**STAFF REPORT:** 8/9/2023 REGULAR MEETING

**APPLICATION NUMBER:** #23-8485

**ADDRESS:** 2405 BURNS

**SCOPE:** REPLACE WINDOWS AND DOORS, REMOVE PAINT, REPAIR STUCCO AND EAVES (WORK COMPLETED WITHOUT APPROVAL)

Figure 3, by Applicant:  
Proposed 2/1 casement  
window for front elevation  
bay.

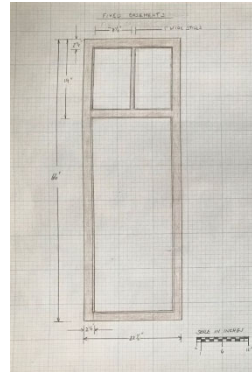
- Staff observed that the applicant has matched the configuration of the historic windows with the exception of the front elevation casement windows: instead of a casement of 2x5 divided light, the applicant proposes to introduce 2/1 divided light per casement window on the first floor casement windows. These would be located on the first floor bay, and two windows have already been installed. (See figures 1-3, Site photo 5). These windows are currently vinyl, previously installed by a previous owner and were present at the time of historic designation. It is staff's opinion that the original configuration was more likely to resemble the 2x5 layout, but it is staff's opinion that the proposed 2/1 configuration is not demonstrably inappropriate.

- Some of the work in this application was completed or started without Historic District Commission (HDC) approval.
- Although the front elevation bay windows were most likely to have a 2x5 configuration of divided light per casement, it is staff’s opinion that the proposed 2/1 configuration is not demonstrably inappropriate and meets the Standards and Elements of Design for Indian Village.
